In Re Application: Tuy Vu Mai  
Serial No.: 10/664,737  
Filed: September 18, 2003  
Art Unit: 5612  
Examiner: Zaneli, Michael J.  
Title: **VEHICLE BASED DATA COLLECTION AND  
PROCESSING SYSTEM**

**RESPONSE TO OFFICE ACTION MAILED DECEMBER 07, 2004**

**Amendments to the drawings** begin on page 12 of this paper and include both an attached replacement sheet and an annotated sheet showing changes.

FIGURE 10

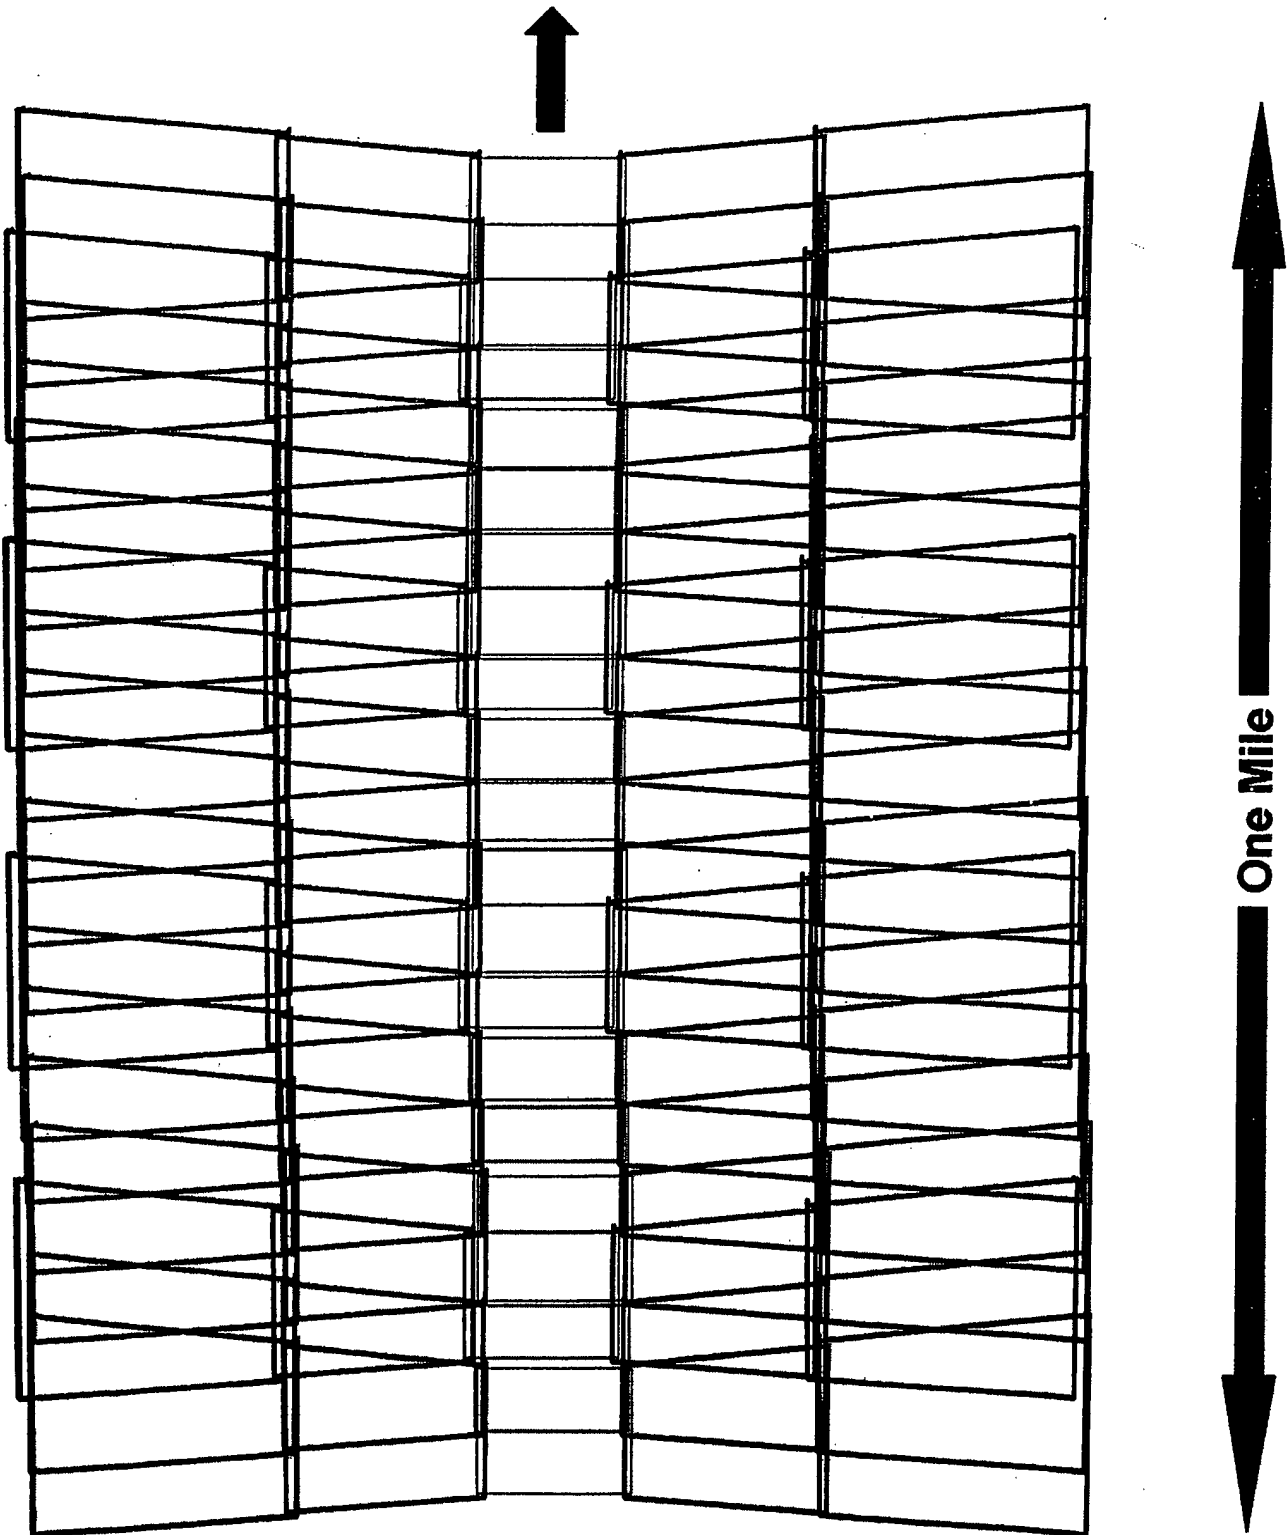
The sheet that includes Figure 10 now replaces the original sheet that included Figure 10. In Figure 10, the lines connecting and identifying certain representational components have been repositioned for reasons of clarity. In Figure 10, the shape of the boxes have been changed and repositioned for reasons of clarity and stylistic preference. Additionally, Applicant has deleted

some of the words in Figure 10, without prejudice and for reasons of clarity. No new matter has been added to Figure 10.

FIGURE 11

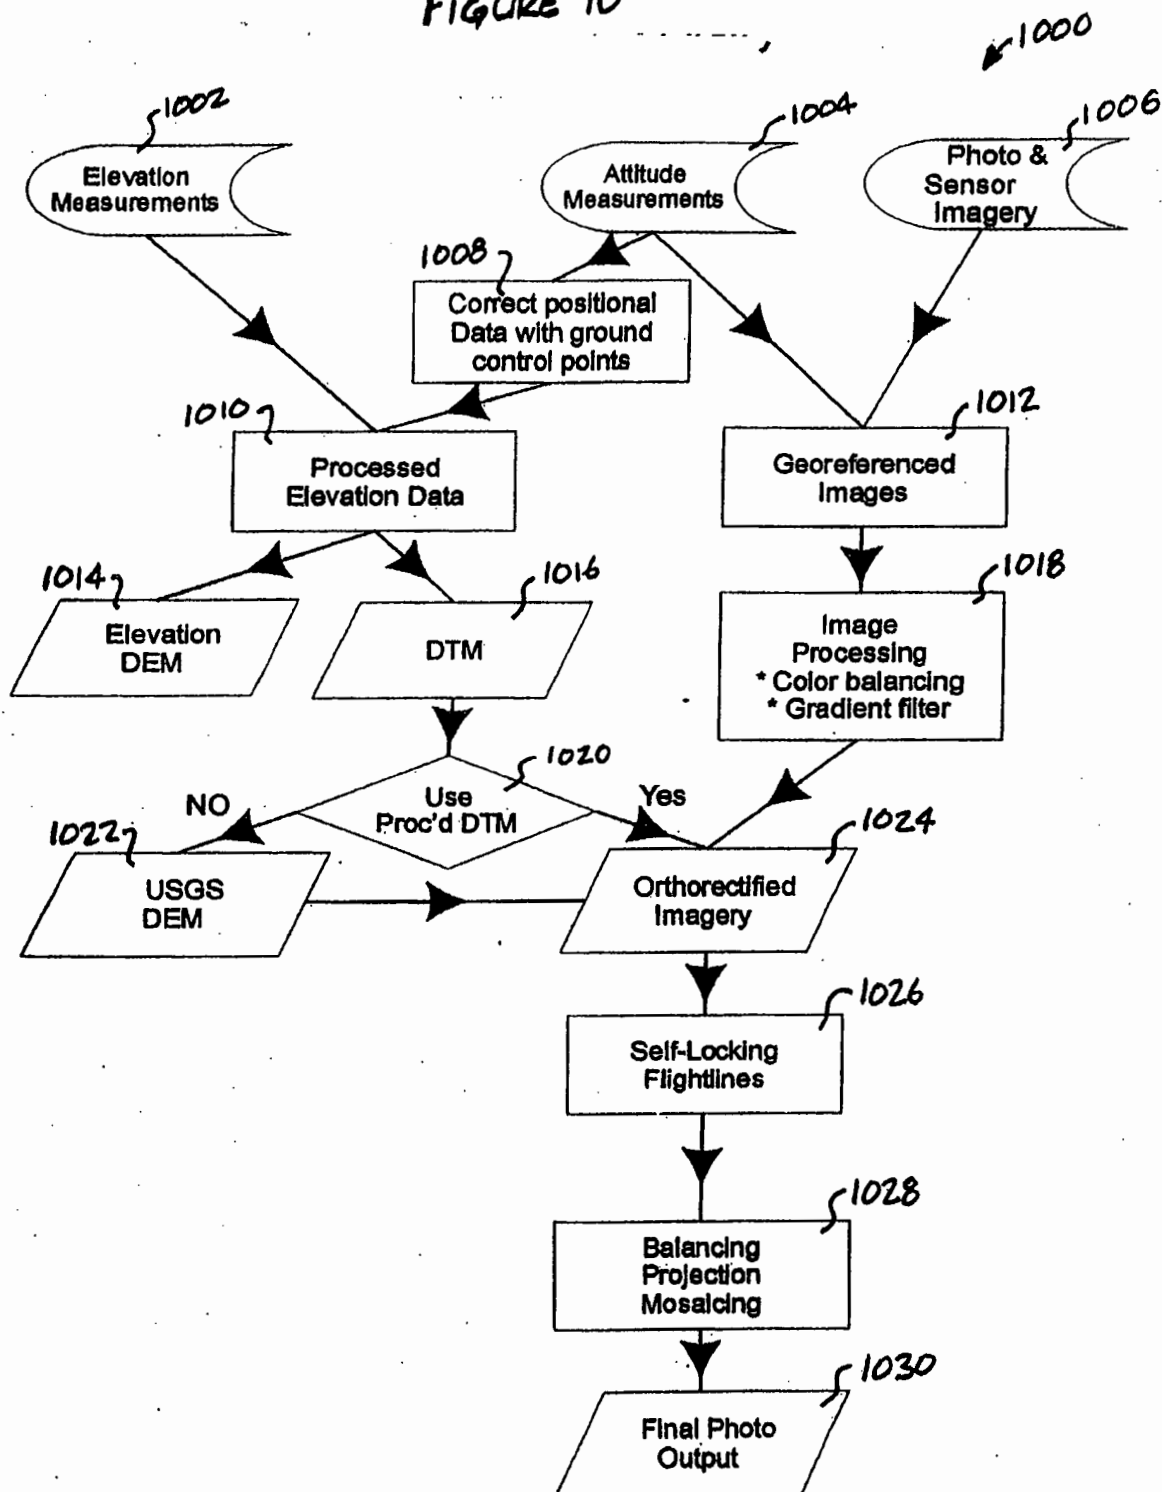
The sheet that includes Figures 11, 12, and 13 now replaces the original sheet that included Figures 11 and 12, and that portion of the sheet that included Figure 13. In Figures 11, 12, and 13 the lines identifying certain representational components have been repositioned for reasons of clarity. In Figures 11, 12, and 13, the boxes have been repositioned for reasons of clarity and stylistic preference. Additionally, Applicant has deleted some of the words in Figures 11, 12, and 13 without prejudice and for reasons of clarity. No new matter has been added to Figures 11, 12 and 13.

FIGURE 14

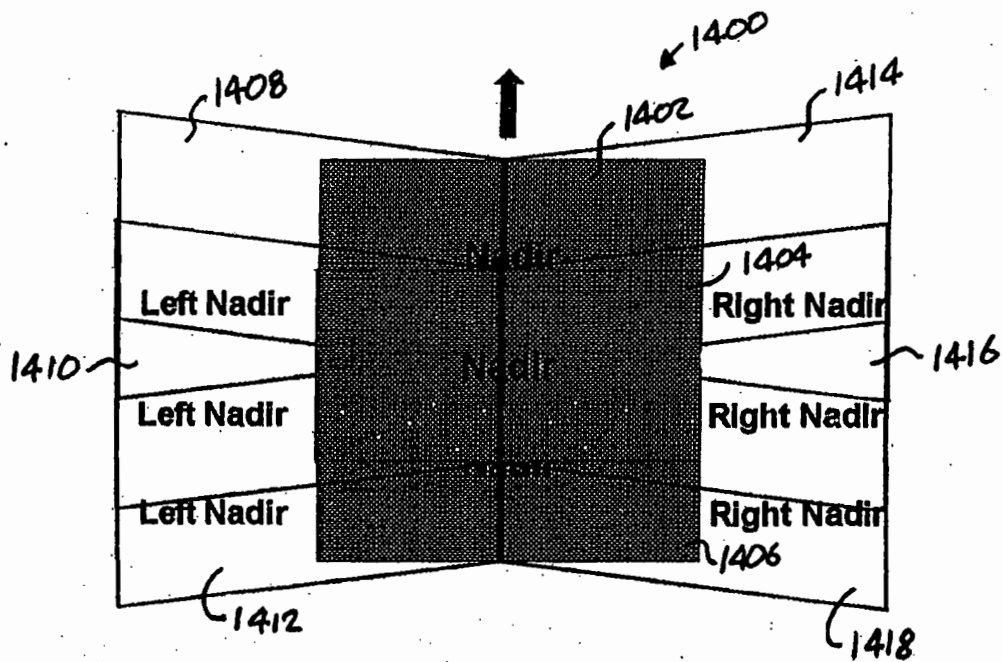
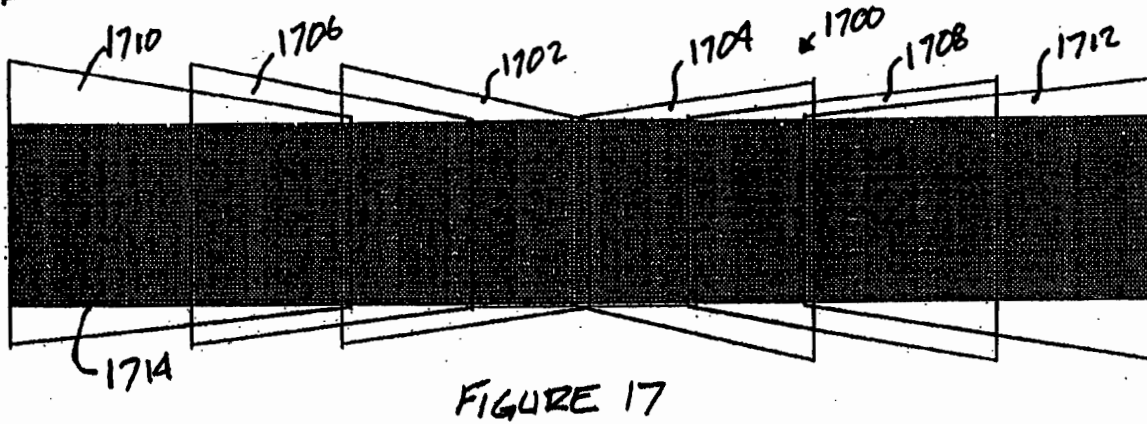
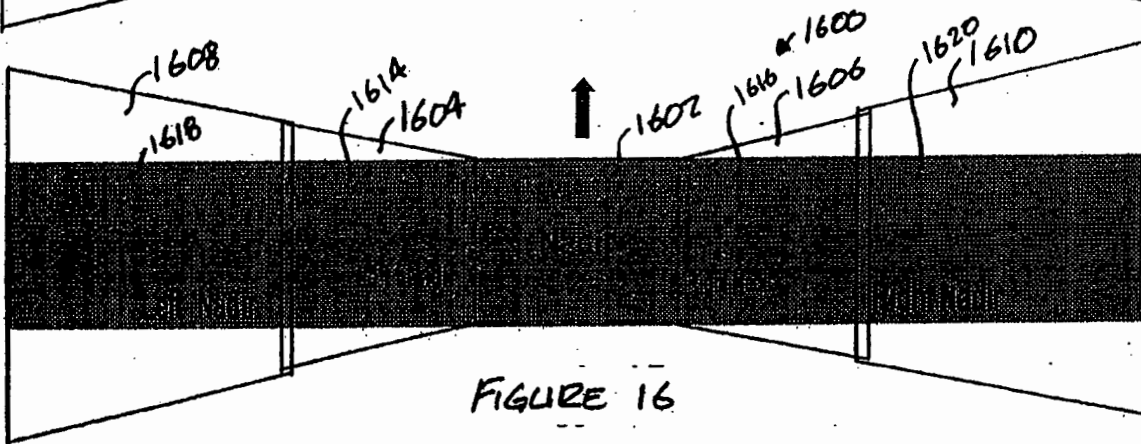
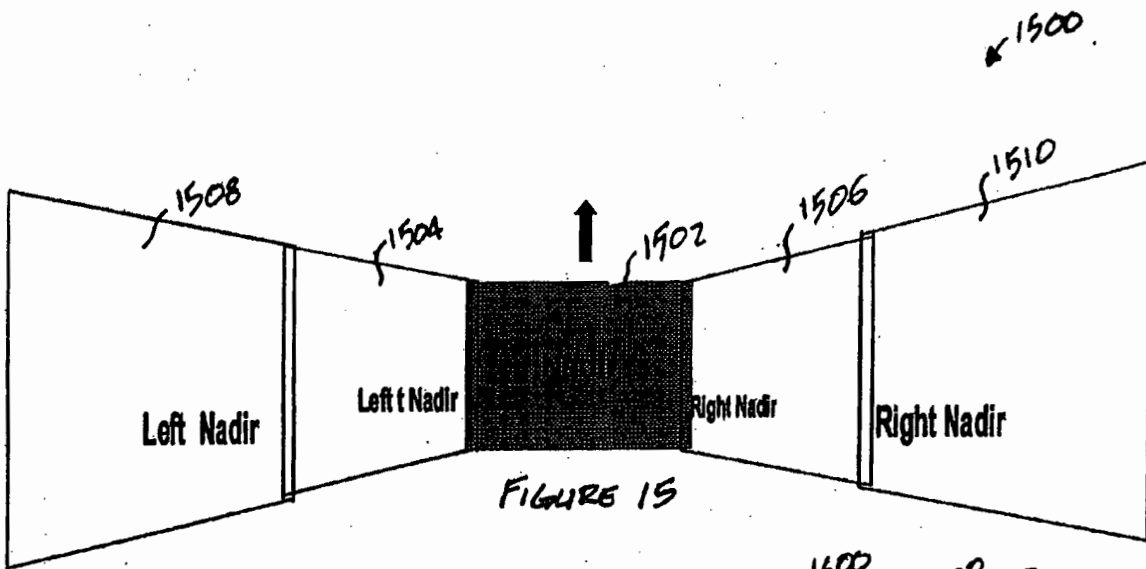
The sheet that includes Figures 14, and 15 now replaces the original sheet that included the portion of the sheet that included Figure 14 and the portion of the sheet that included Figure 15. In Figures 14 and 15 the lines identifying certain representational components have been repositioned for reasons of clarity. In Figures 14 and 15, the shape of the boxes have been changed and repositioned for reasons of clarity and stylistic preference. Additionally, Applicant has deleted some of the words in Figures 14 and 15 without prejudice and for reasons of clarity. No new matter has been added to Figures 14 and 15.

FIGURE 18

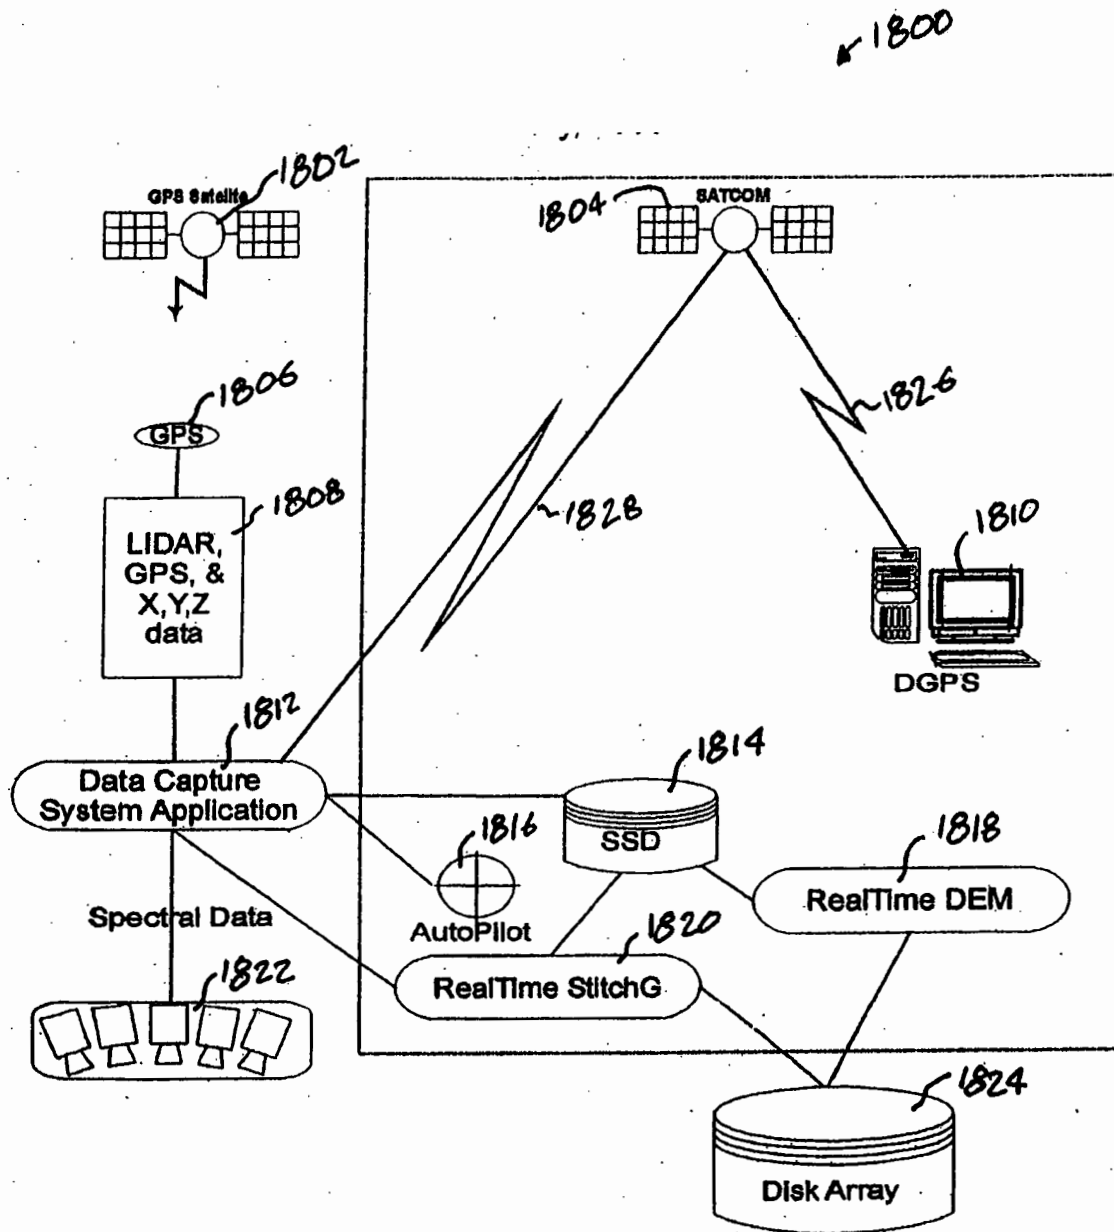
The sheet that includes Figure 18 now replaces the original sheet that included Figure 18. In Figure 18, the lines connecting and identifying certain representational components have been repositioned for reasons of clarity. In Figure 18, the shape of the boxes have been changed and repositioned for reasons of clarity and stylistic preference. Additionally, Applicant has deleted some of the words in Figure 18, without prejudice and for reasons of clarity. No new matter has been added to Figure 18.
